MEETING AGENDA OF THE CLEARFIELD CITY PLANNING COMMISSION

STAFF REPORT

SUBJECT: Discussion and Possible Action on **CUP 1905-007**, a conditional use permit request by Brad Carter with NovaSource Sunwest, LLC to construct a Valvoline Instant Oil Change center at the subject property. **Location:** 856 West Antelope Drive (TIN: 12-667-0024). **Parcel Area:** 0.41 Acres. **Zone:** C-2 (Commercial). **Planner:** Brad McIlrath (**Administrative Matter**).

ARCHITECTURAL
ELEVATIONS

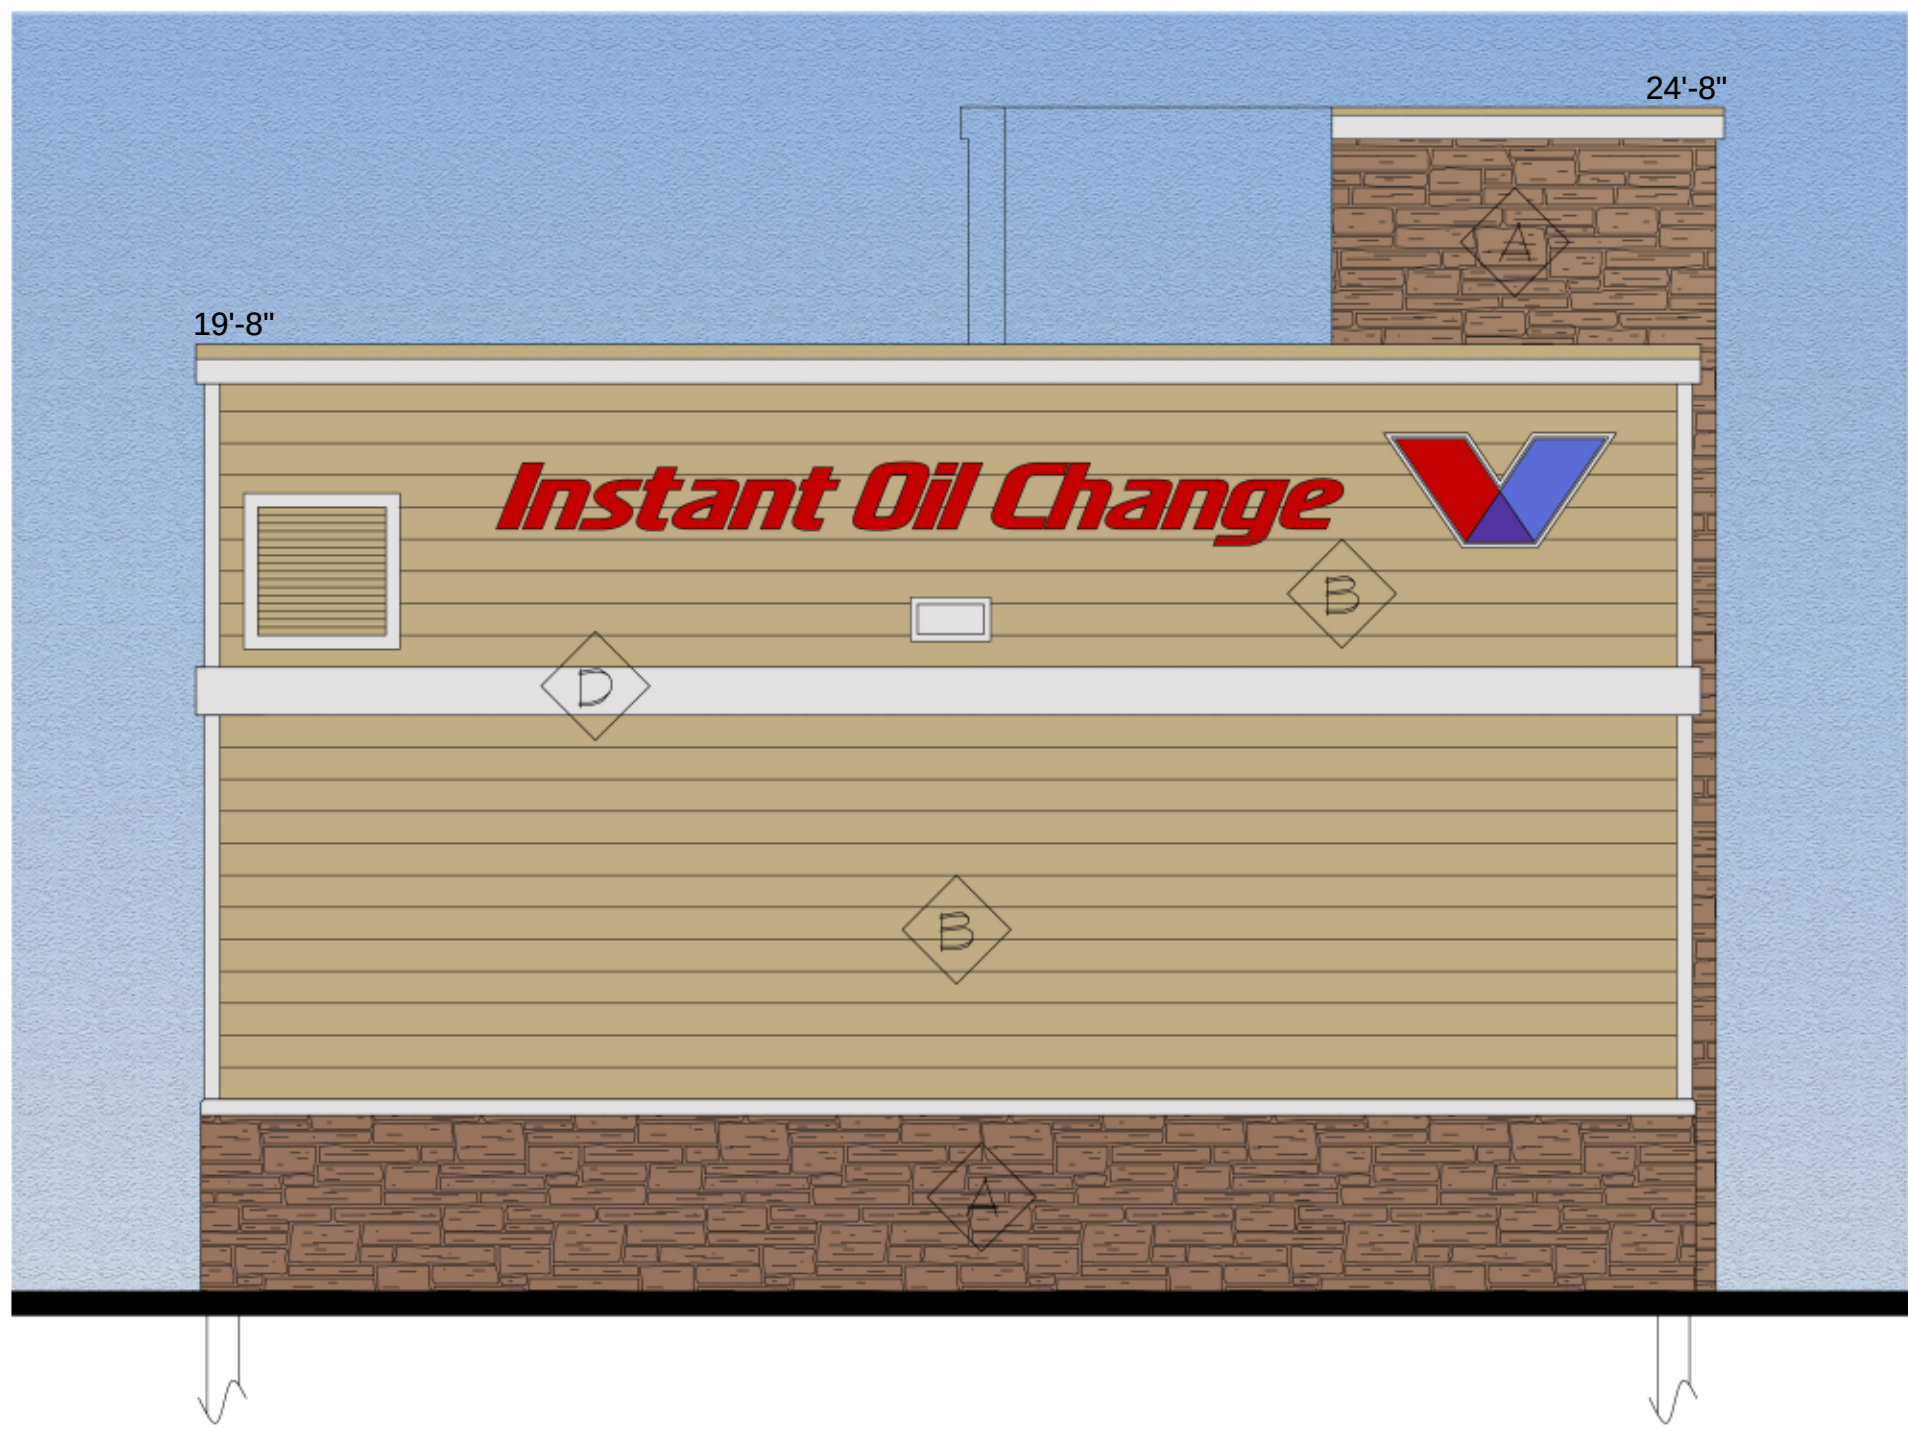
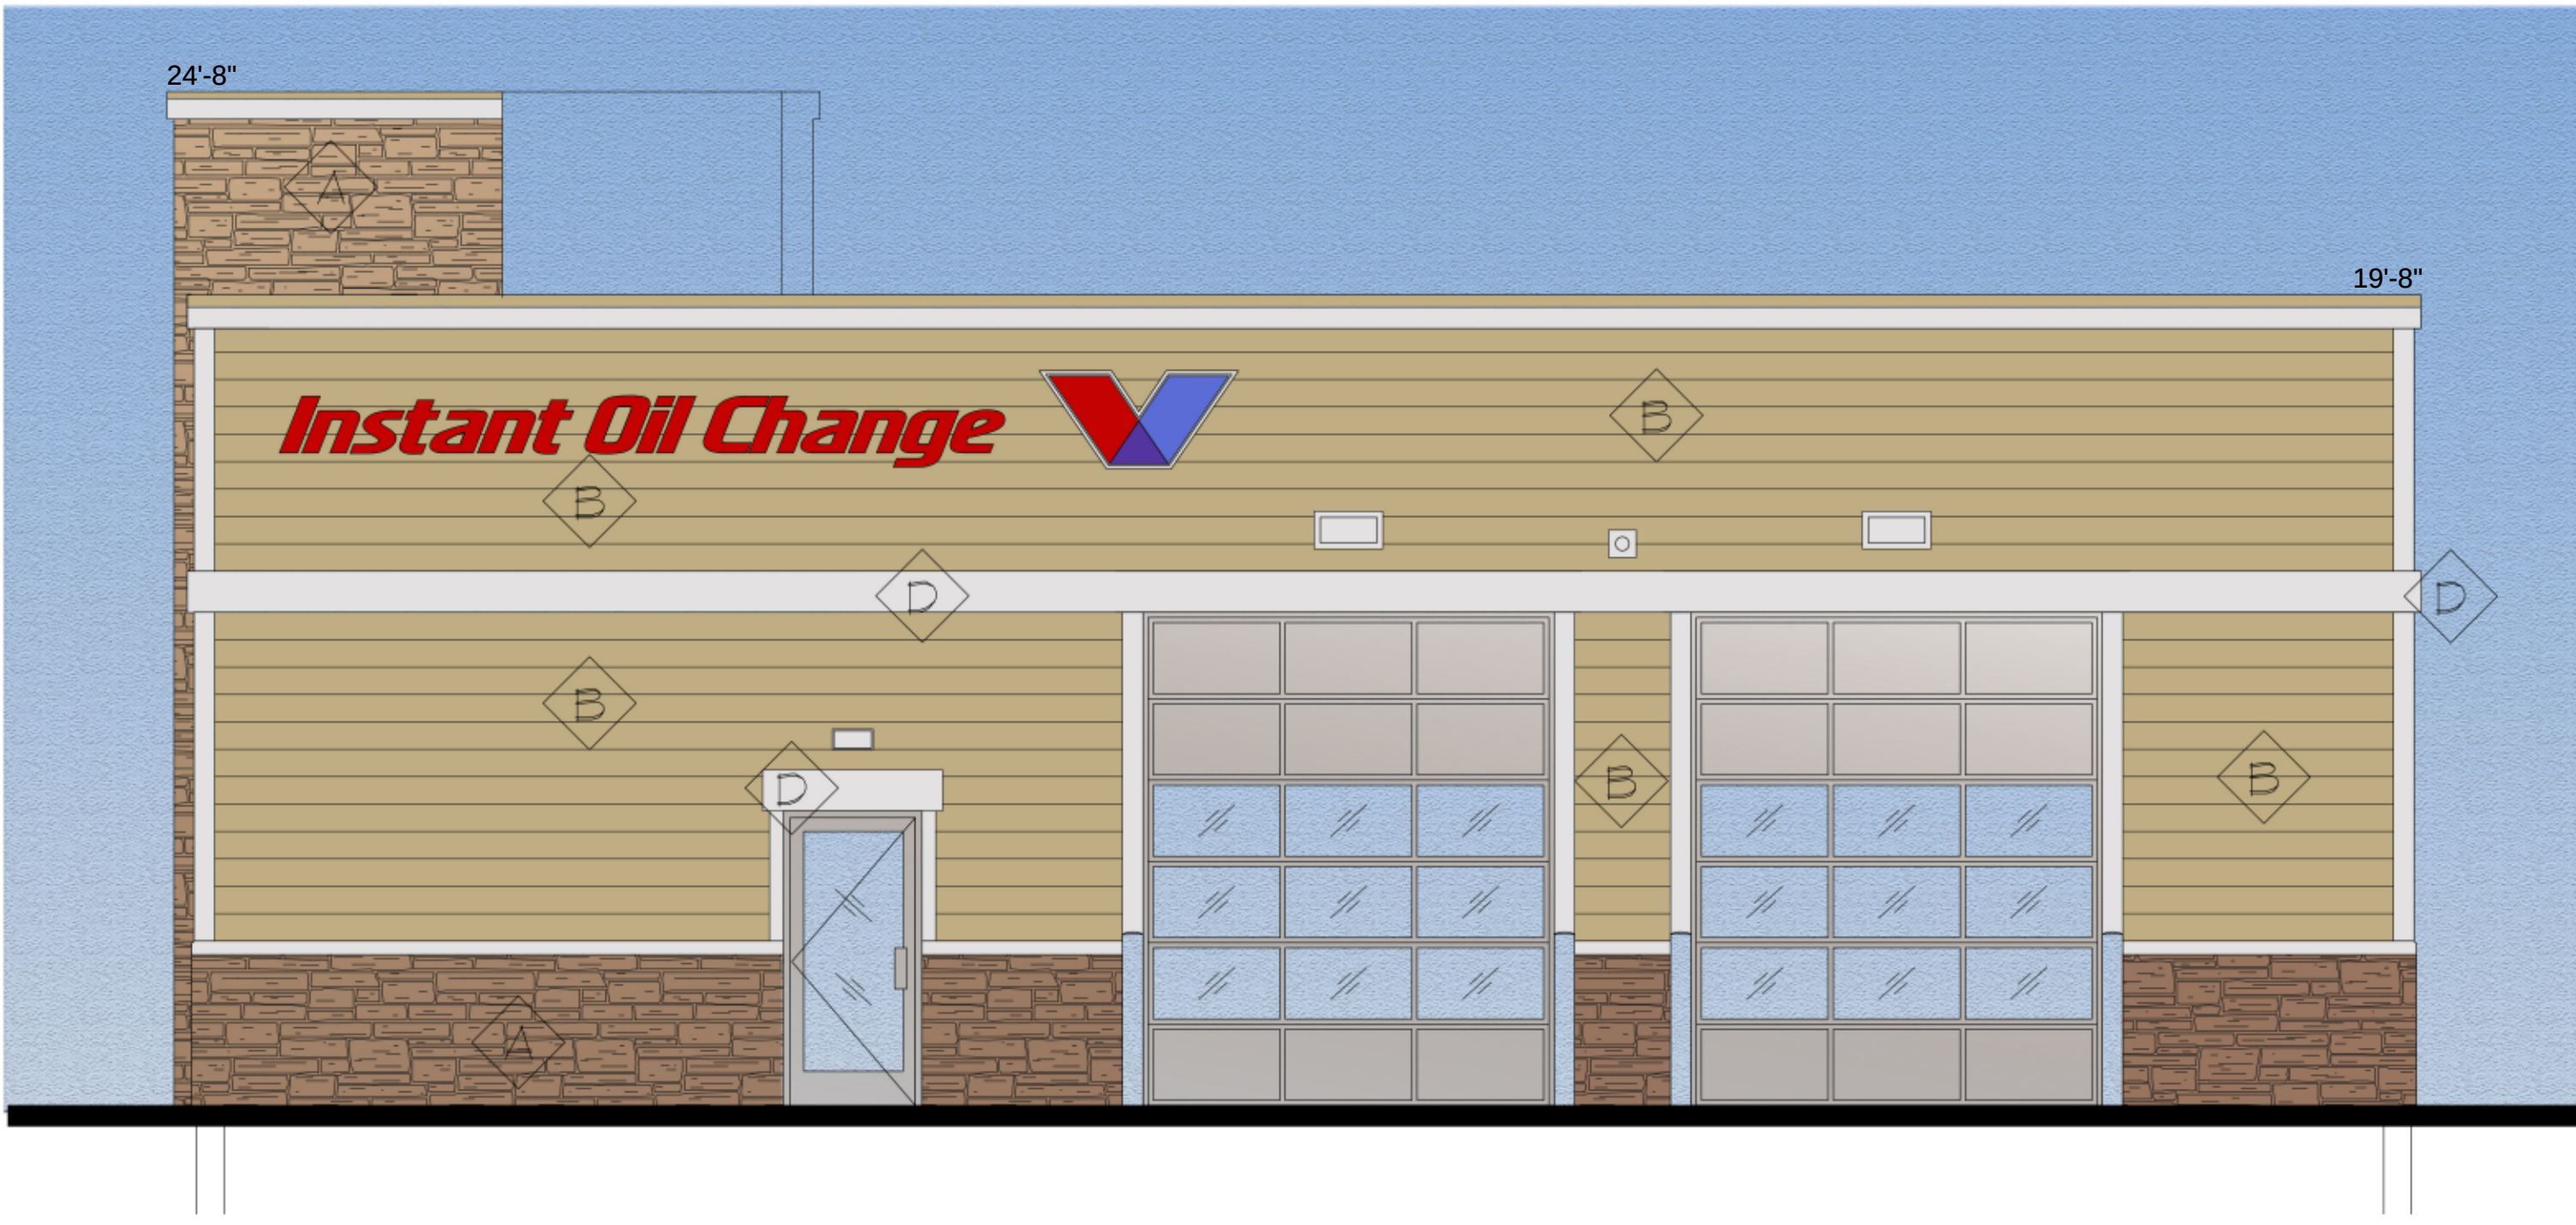
Chapters 11-11B “Commercial Zone C-2” and 18 “Design Standards,” outline all of the site and building design standards required for new development or major changes to a site within the City. As required by the C-2 Zone, the building must include brick, stucco, rock, or vinyl siding. Any building elevation facing a street right of way must have at least two (2) of the following: brick, stucco, stone, or rock. The proposed building materials include the use of a stone veneer along all elevations and predominantly along the front façade. The street elevation will need to be revised to include one additional material listed above. The building also includes the use of hardie plank lap siding and a metal awning over the front entrance. All of the materials that are proposed are of high quality and should be allowed. Staff recommends that the project be approved as proposed with the needed additions to the front elevation.

- 5) The pedestrian path across the parking lot shall be constructed of a separate material then the parking as required by ordinance.
- 6) The front building façade materials shall be revised to comply with the approved materials outlined in the C-2 zone.
